APPLICATION NO.

**SA2023/029**

**14 NELSONS BUILDINGS ROAD, BRIGHTON**

**2 LOT SUBDIVISION**

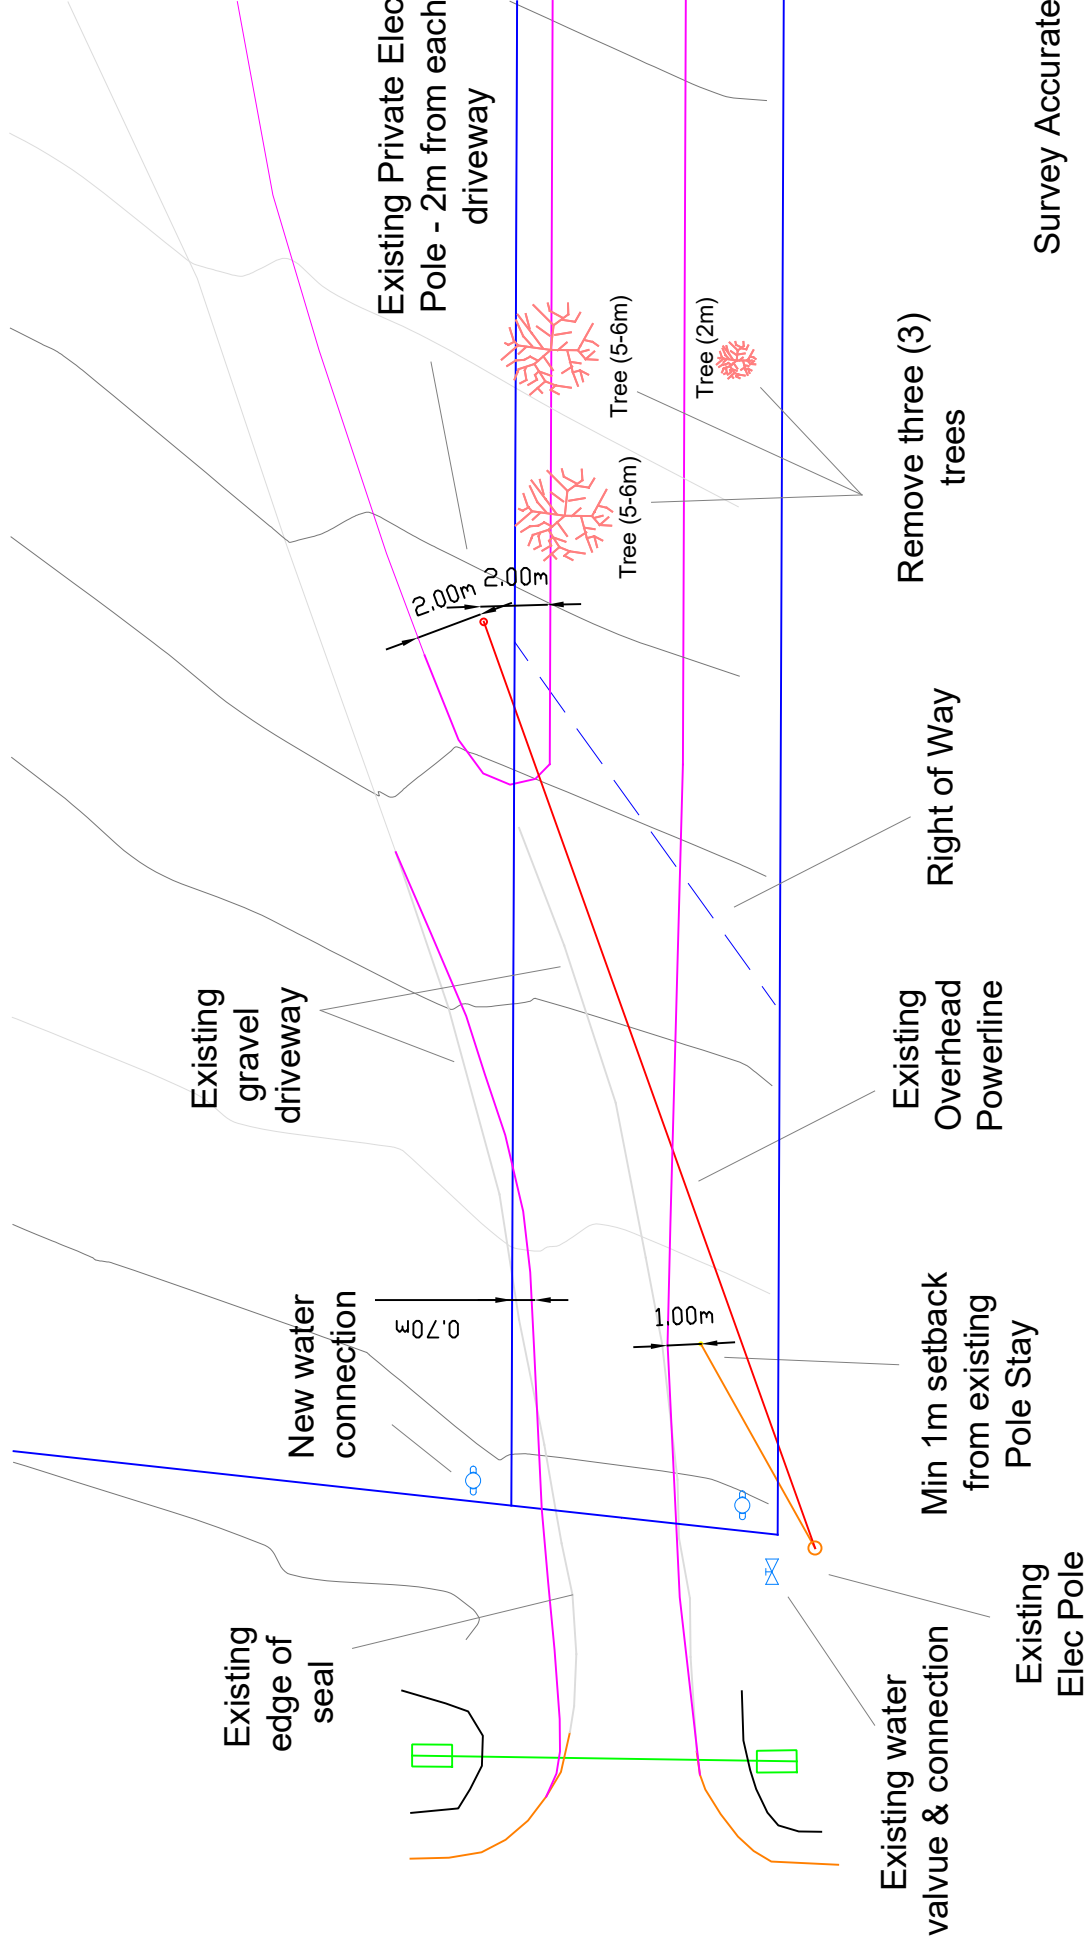
*Clarification is sought as to whether the proposal requires alterations to the entry access and how the new internal access road will transition off the entry and around the pole stay wire and the private pole. Any changes required will need to be shown on an amended plan. Perhaps an enlarged Image of this section of the proposal could be provided?*

*Any vegetation that needs to be removed from site will need to be shown on an amended plan.*

The existing private pole is 8.810 metres from the existing side boundary and therefore 0.810metres from the proposed boundary. A setback of 2 metres from each driveway is proposed (see attached enlarged plan).

The existing pole stay is 2.330 metres from the side boundary. A clearance of 1 metre from the stay would provide the (4 metre wide) access with a clearance of 0.7 metres on the northern side. A 1 metre clearance would seem more than adequate given the location of the stay on private land and in a exceptionally low speed location. The stay is also located between the boundary fence and the white entry fence. The entry fence provides for an additional physical barrier and traffic calming device.

The application requires the removal of three (3) trees as shown of the same attached plan, google earth picture and photo. Two trees are 5-6 metres in height and a third tree is no more than 2 metres in height. All three trees are eucalypts and are of “stunted” appearance. There is a significant number (40+) of other trees remaining on Lot 1.
